Symptom:

The SZW133's LCD Screen displays gibberish characters..

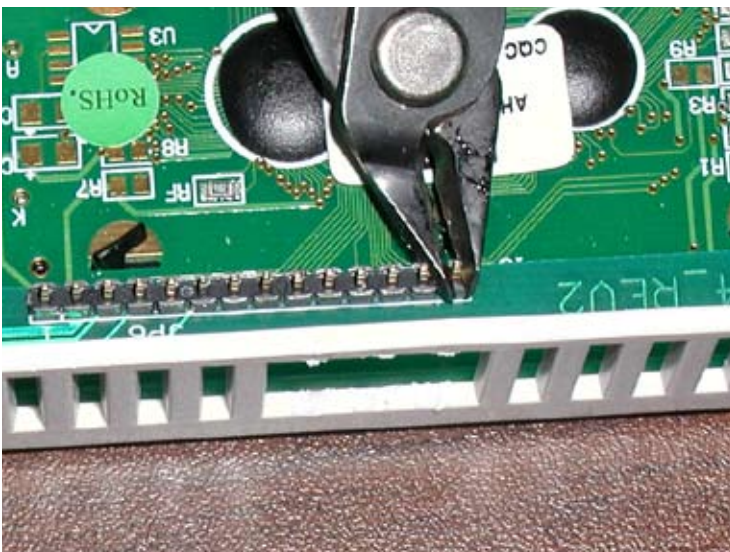
Some SZW133s were manufactured with longer leads connecting the LCD screen to the PCB, and when the top half and bottom half are screwed together tightly, it would cause a short across some of the LCD leads as the leads made contact with the top of a capacitor. See picture below (part of the enclosure has been removed).

Trim the lead length to prevent the leads from hitting the capacitor.

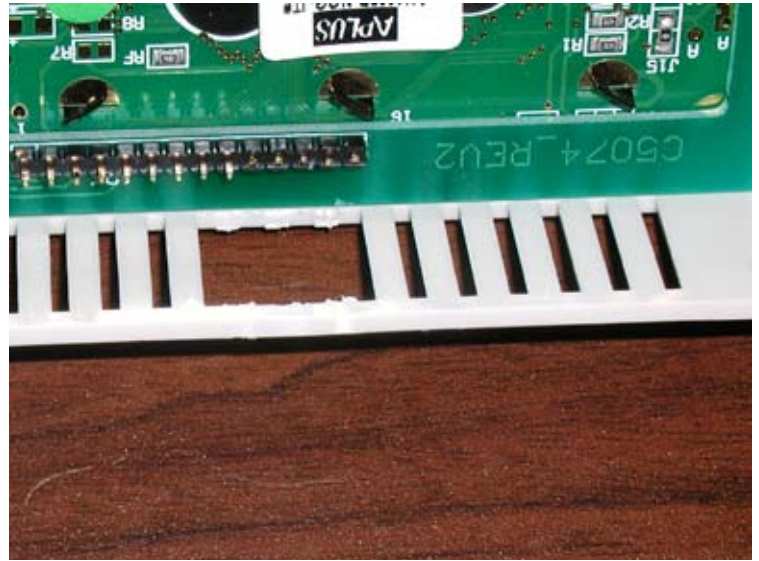
1. Separate the two halves (cover and base) of the thermostat.
2. Remove power from the 24+/- (Black) terminal block.
3. Using side cutters, trim the five (5) right hand pins down the black plastic stop.

4. After trimming those pins, there should be plenty of room for the capacitor.
